FORD CFT30/CVT TRANSMISSION TURBINE SHAFT SEALING RING CHANGE

Figure 1

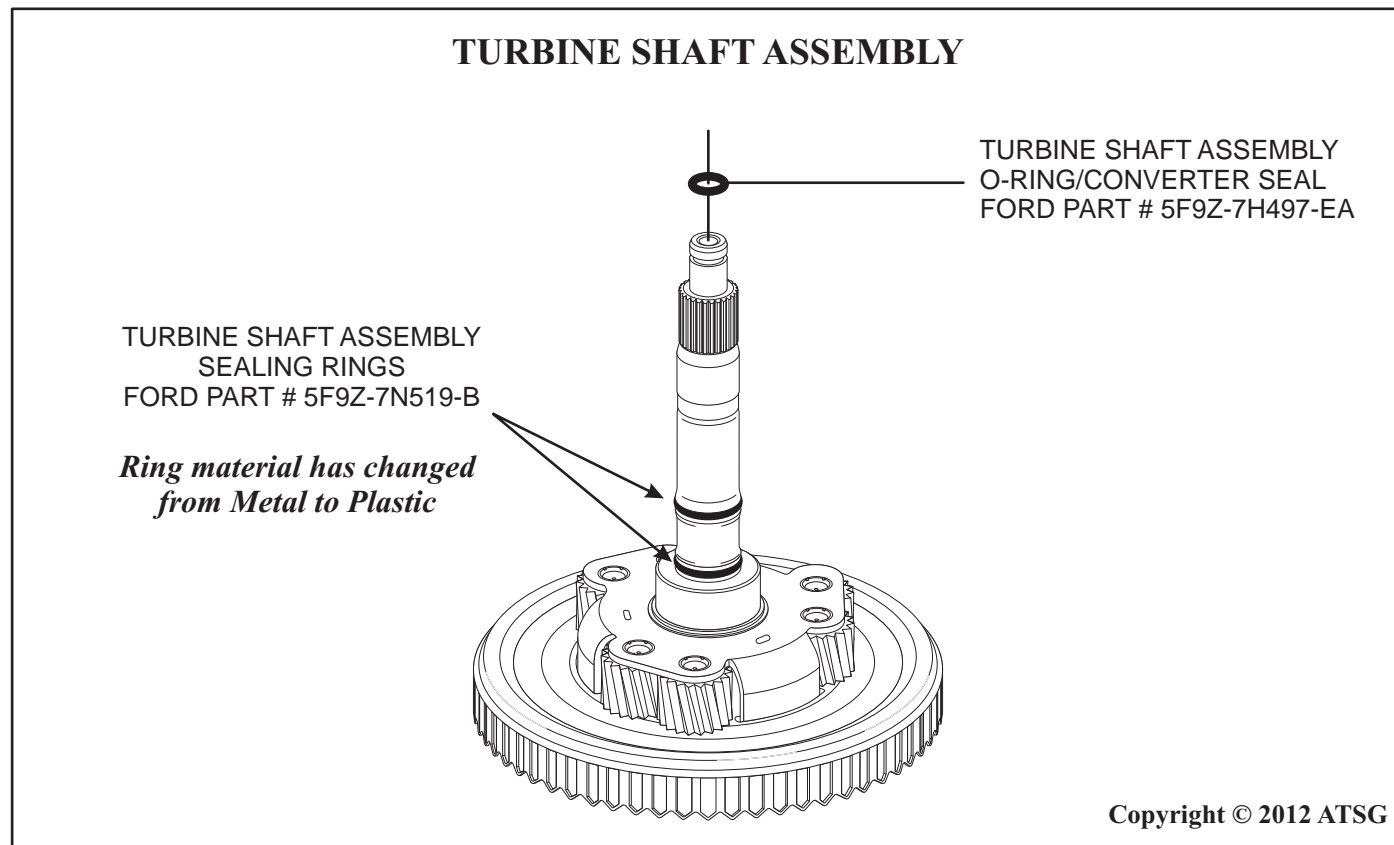
CHANGE: As a running change, the two sealing rings on the turbine shaft, as shown in Figure 1, have changed from a metal ring to a plastic ring.

The new design will service the previous design.

TURBINE SHAFT SEALING RING (Ford part number).....5F9Z-7N519-B
